SUBJECT:
DTC P0171 SYSTEM TOO LEAN

No: **TSB-06-13-009**

MODEL: **2004-06 Lancer 2.0L**

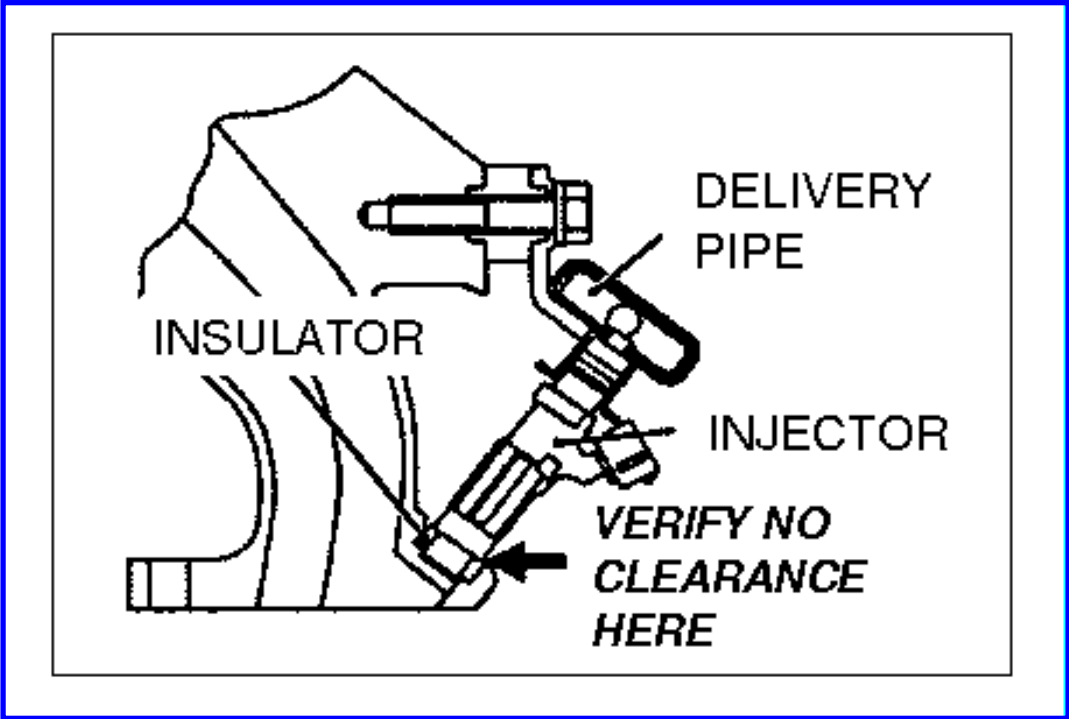
Replace the O-ring and insulator on all fuel injectors, using the parts listed below.

Verify that there is **no clearance between the insulator and the injector**. Install the injectors on the fuel rail.

After the fuel rail is installed on the engine, **be sure to press the injectors firmly down against the insulators**.
